Staff Report - Certificate of Appropriateness Application

File Number: 3-F-20-HZ

PROPERTY LOCATION: 215 Sixteenth St. / Parcel ID 94 N E 019

3-F-20-HZ
APPLICATION FOR CERTIFICATE OF APPROPRIATENESS

East

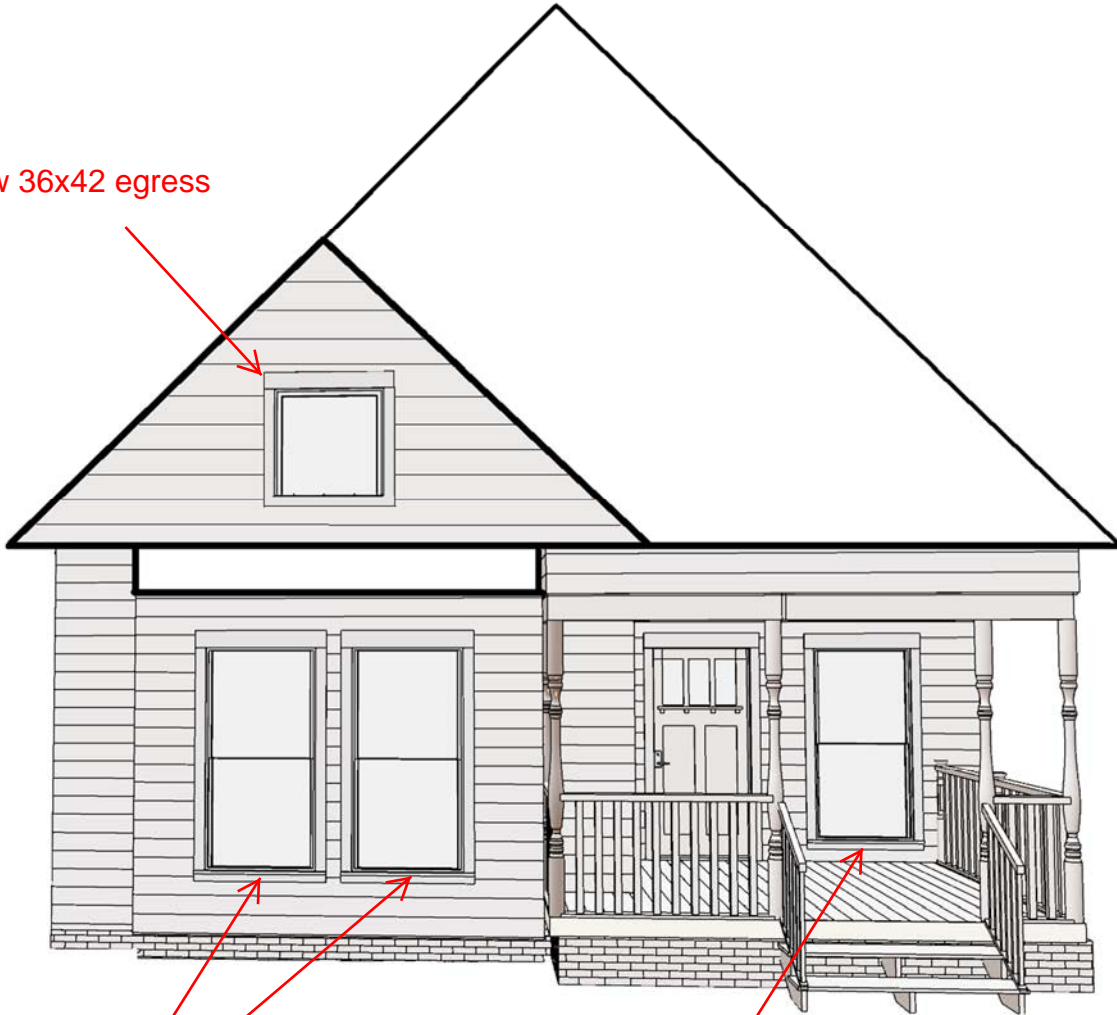
4. The proposed egress windows meet the minimum size requirement for building code. While applicant has installed egress windows in side gable fields in multiple instances in the Fort Sanders overlay, a full-sized egress window of 36" by 42" is not appropriate for the façade front gable. The renderings provided by applicant are not to scale and the proposed egress window would be too large for the historic proportions of windows.

Staff recommends approval of the work proposed, with the following conditions: 1) omit egress window in façade (east) gable field (smaller casement window for natural light, if necessary, could be approved by staff); 2) paired windows on south elevation remain the same size as the original windows; 3) reconstructed front porch retain shed roof and square columns as existing; 4) if foundation must be reconstructed in locations other than front porch, under façade bay window, and rear addition, a revised application for a COA be submitted; 5) final drawings submitted for permitting to match specifics of the proposed construction, including final window placement and size; a shed-roof porch; and a shed-roof rear addition

New 36x42 egress

West

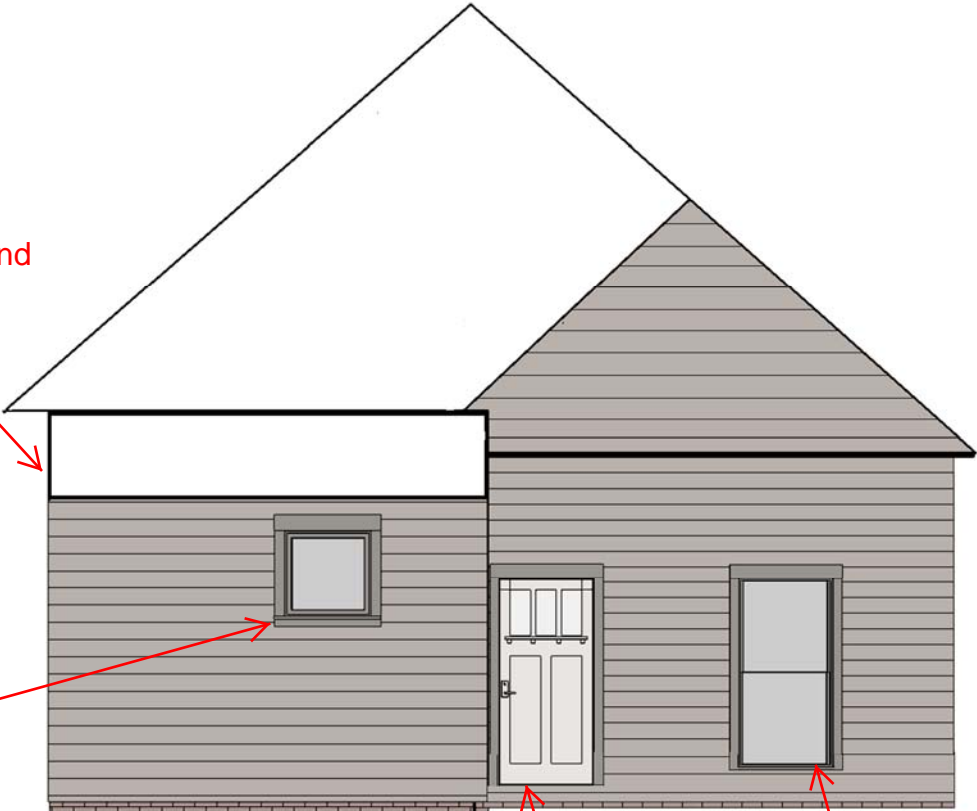
3. The rear addition is modest and does not detract from the overall architectural integrity of the house. It is sufficiently offset from the south elevation to differentiate it from the historic house. The proposed rear addition will feature materials that are appropriate within the guidelines. The rear addition should retain a shed roof similar to the existing or the addition constructed at 207 16th, instead of the hipped roof on the renderings.

enclose existing porch, like 203 and 207, shed roof

New 24"x24" Casement

Shift rear door over to align with hallway like 203 and 207 16th.

South

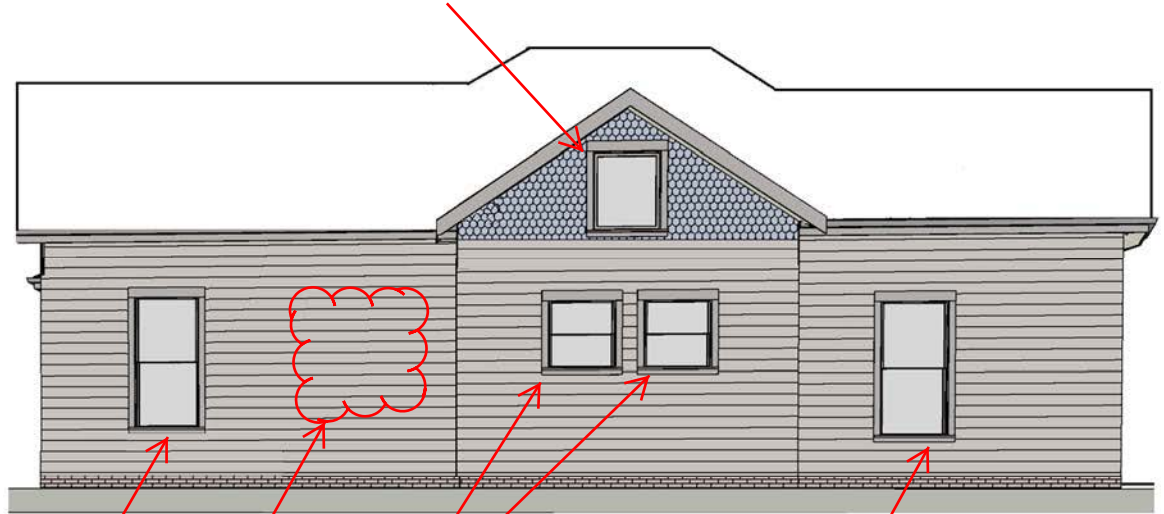
5. The proposed replacement 1/1 vinyl windows are appropriate under the Fort Sanders NC guidelines. However, partially enclosing the paired windows on the south elevation does not retain window proportions and symmetry that reflects the historic context.

New 36x42 egress

Enclose to 36"x36"
instead of 36"x72"

North

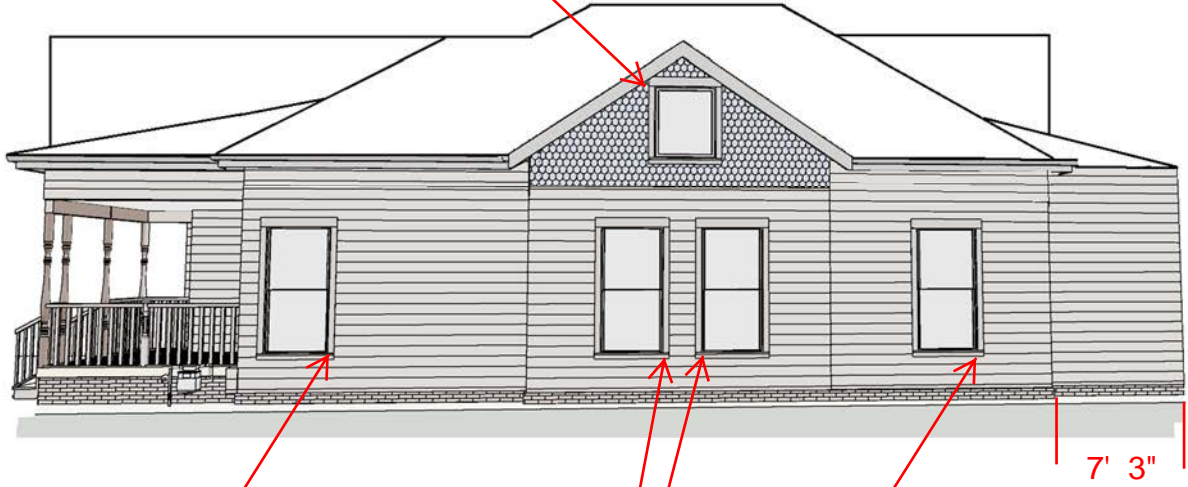
New 36"x42" egress window

Shift 18" to front so its not in the staircase.
Size to remain same.
36"x72"

Change existing 28"x42" to 36"x72". Existing casement will not meet egress code.
